ITEM 7. DEVELOPMENT APPLICATION: 437 WATTLE STREET ULTIMO

FILE NO: D/2007/2522

Proposal Summary: Alterations and additions to four (4) existing terraces and new residential building with 14 units on 4 levels, (with basement car park for 7 vehicles) to be constructed behind the existing terraces that front Wattle Street (18 Units total).

Figure 1. Corridor from foyer to window providing natural Light and Ventilation on each level

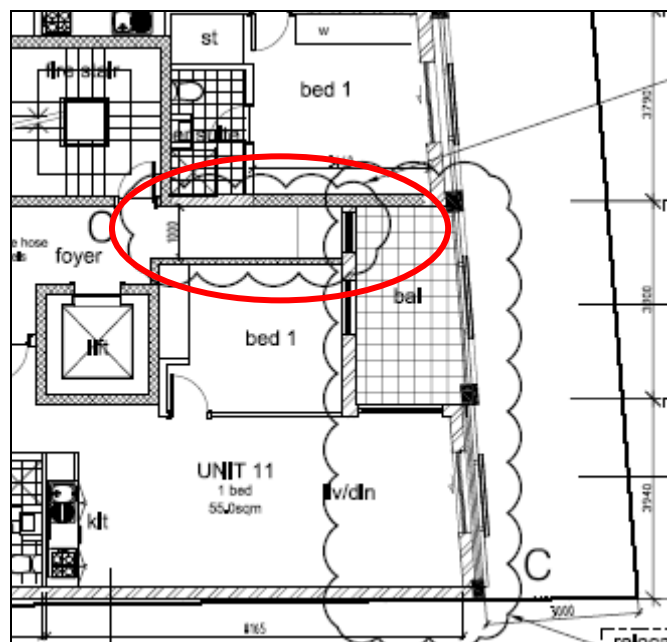
- (a) the 'internalised' foyer should be redesigned to be naturally lit and ventilated for a more sustainable outcome;
 - (b) the courtyard to the terraces could have better sun access through a reduction in the bulk of the proposed apartment building i.e. setback of the fourth floor; and

- (c) the entry to the lifts should be accessible.
2. Further plans were submitted showing the following changes:
 - (a) the floor plans have been amended to provide light & natural ventilation to the entrance lobby and core above;
